V2500-A1/A5/D5 PROPULSION SYSTEMS SERVICE BULLETIN

This document transmits Revision 2 to Service Bulletin EV2500-72-0381 and the Initial Issue of the Supplement

V2500-ENG-72-0381

ENGINE – PROVIDE NEW STAGE 1 HIGH PRESSURE TURBINE (HPT) COOLING AIR DUCT ASSEMBLY
WITH DECREASED HONEYCOMB SURFACE

Modification of the Stage 1 High Pressure Turbine Duct Assembly
Figure 2 (Sheet 2 of 4)

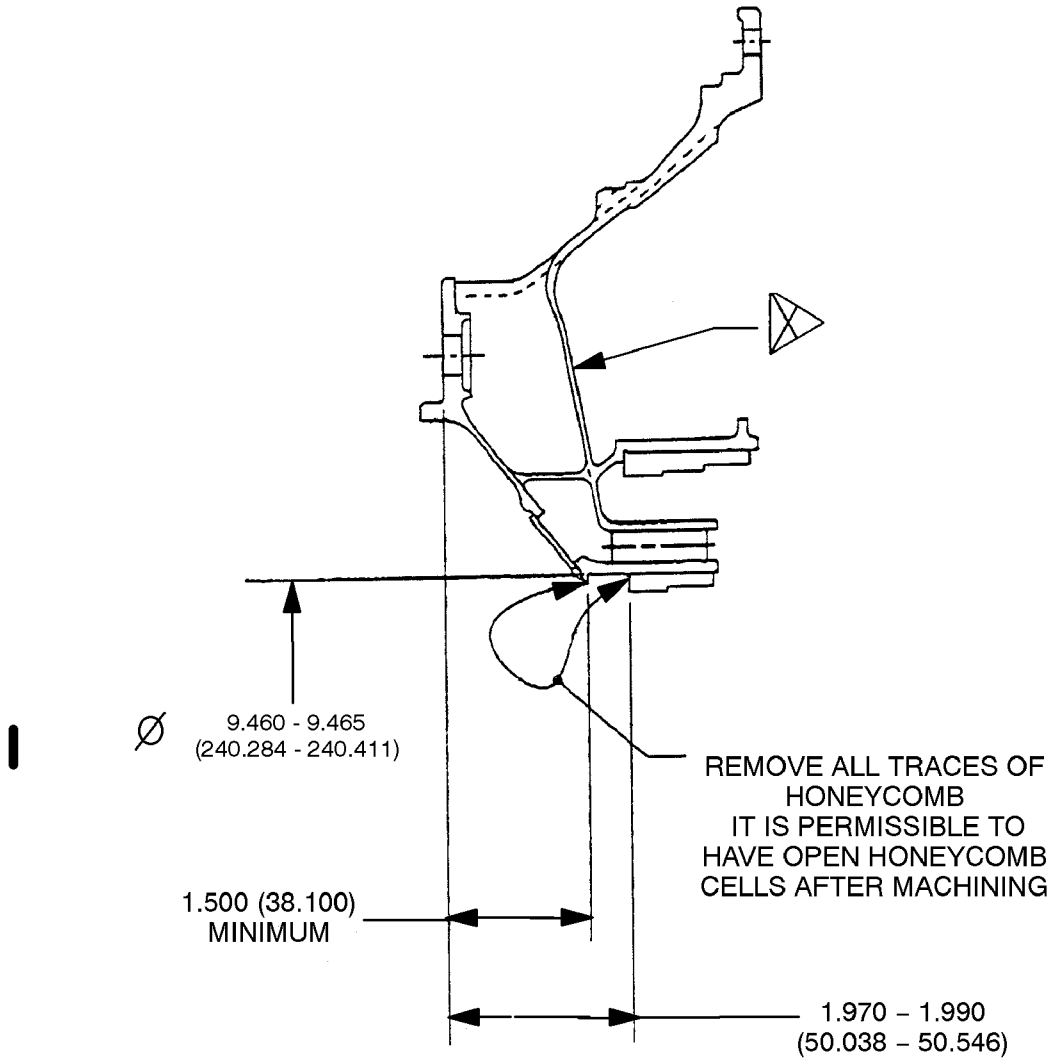
Remove	Incorporate	Reason for change
	Page 1 and 2 of the Summary	To correct dimension in Figure 2 Sheet 2 and to bring the Service Bulletin in line with the new format.
All pages of the Service Bulletin	Pages 1 to 13 of the Service Bulletin	To correct dimension in Figure 2 Sheet 2 and to bring the Service Bulletin in line with the new format.
	Pages 1 to 3 and 5 of Appendix 1	To correct dimension in Figure 2 Sheet 2 and to bring the Service Bulletin in line with the new format.

Reason for change
To correct dimension in
Figure 2 Sheet 2 and to
bring the Service Bulletin
in line with the new format.

(a) Set-up and remove the honeycomb per the dimensions shown in Section A-A Sheet 2. Refer to Figure 2 (Sheet 3).

Modification of the Stage 1 High Pressure Turbine Duct Assembly
Figure 2 (Sheet 3 of 4)

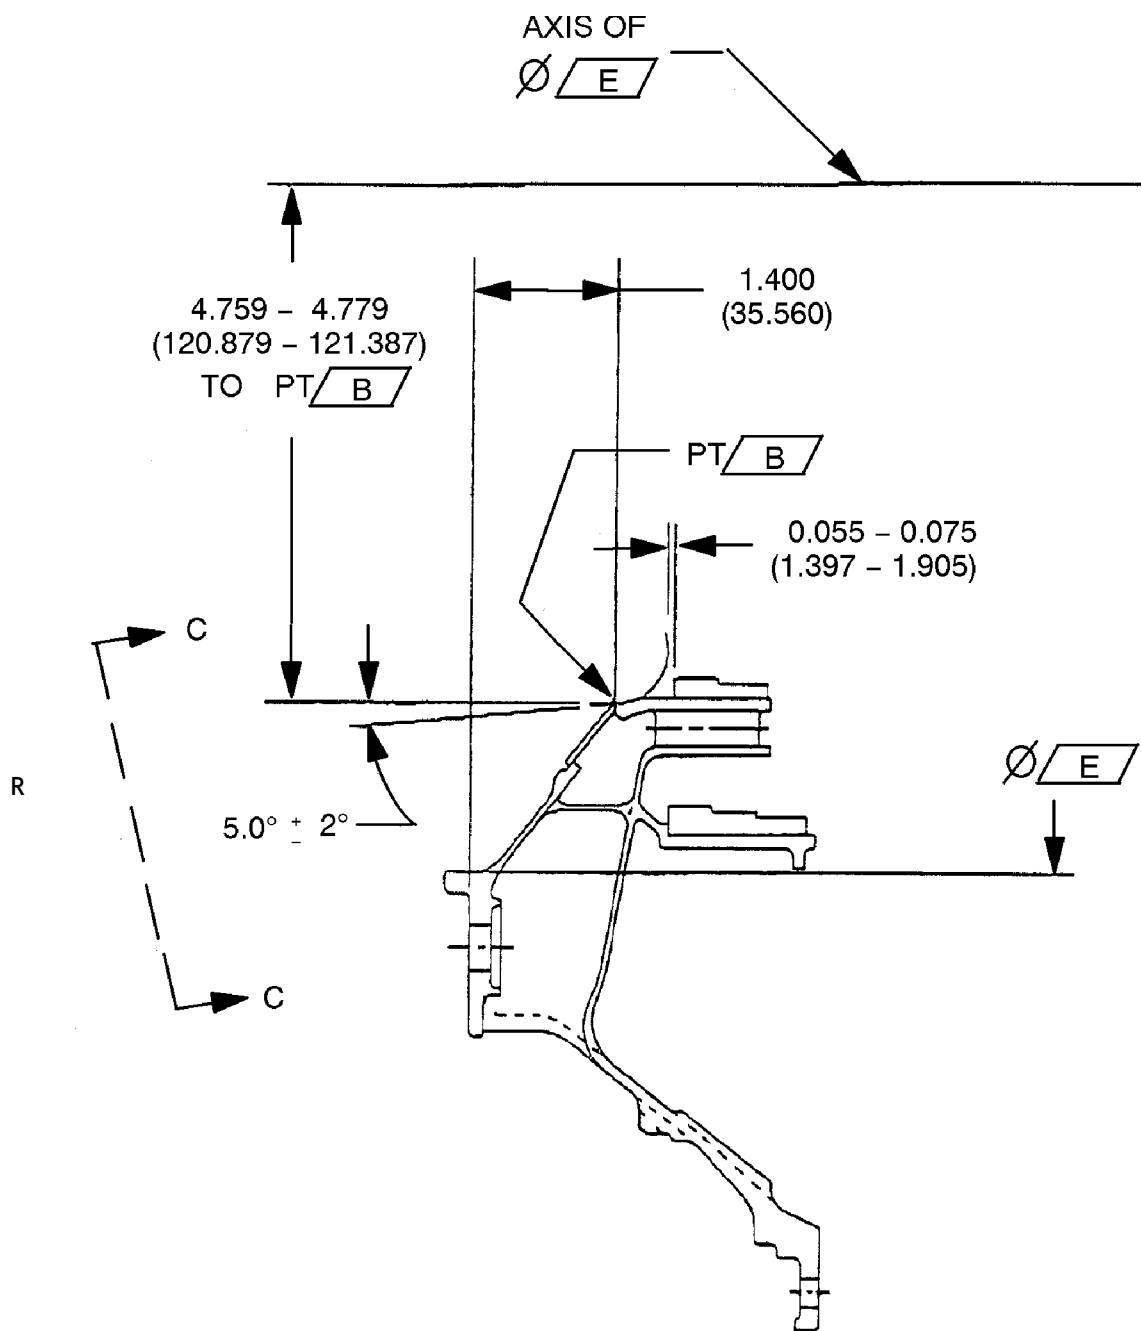
(b) Set-up and machine a slot at bottom dead centre to the dimensions shown in Section B-B Sheet 3 and View C Sheet 4. Refer to Figure 2 (Sheets 3 and 4).
